Blue Planet Knitwear Ltd. (Extension)

Mulaid,Tengra,Mawna, Sreepur, Gazipur
(23.8972559240, 90.431362578)
28 March 2023

Observation: Dinning warehouse

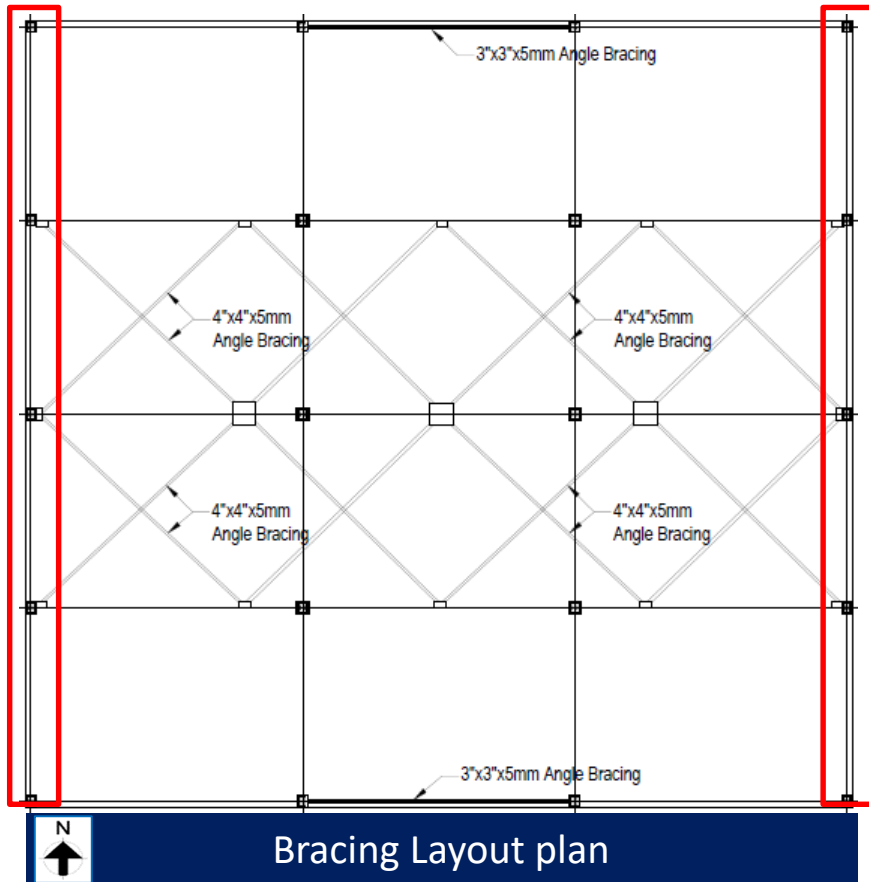
Absence vertical bracing along out of plane of portal frame in north-south direction of the shed.

Building engineer is required to check the lateral stability system of the shed and suggest the necessary vertical bracing where required.
